Appendix C

Early Project Correspondence

TAUM SAUK UPPER RESERVOIR
REPORT ON SAFETY

REPORT OF INSPECTION
TAUM SAUK UPPER RESERVOIR

*TAMM SHARK UPPER DESANDING
Location of Looking Flow Gages*

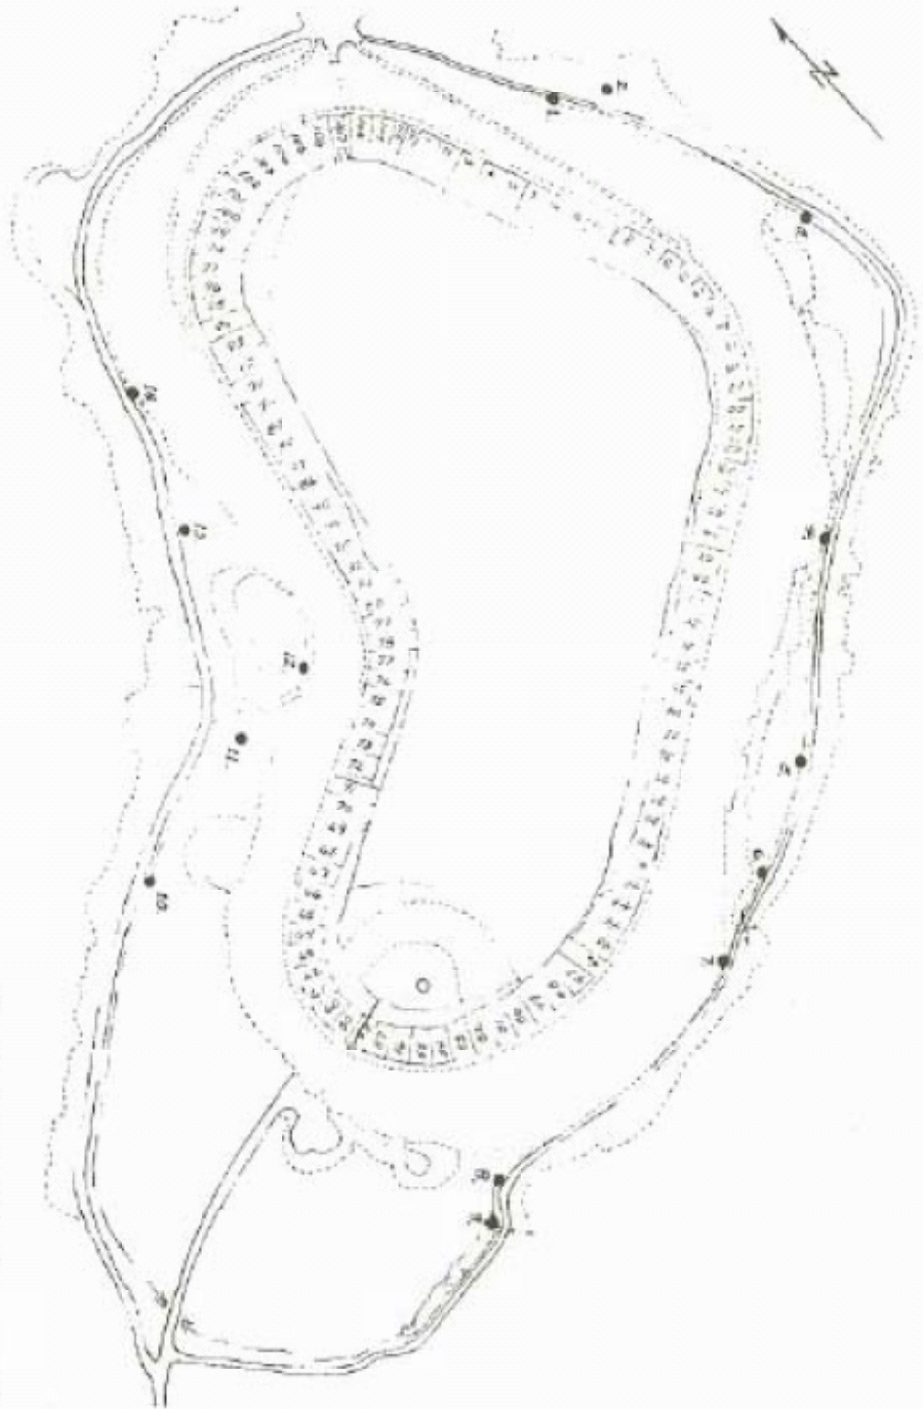
Gage No.	Gage Height*	Condition of Gage	Comments
1	12"	OK	
2	9"	OK	
3	13 1/4"	OK	
4	7"	OK	
5	28 1/4"	OK	
6	19 1/2"	OK	Little rattle noise
7	16 3/4"	OK	
8	16 1/2"	OK	
9	-2 3/8"	OK	
10	21 3/4"	OK	
11	16"	OK	
12	8 1/4"	OK	
13	-6 3/8"		installed at gage 26 1/2" equivalent men removing slide near slide channel discharge
14			
15	30"		
16			
17

General Comments: Leakage was generally down except for area between panels 28 & 102 where it has increased. Drainage channel below panel 30 should be opened to allow water passage to relieve head on sink hole.
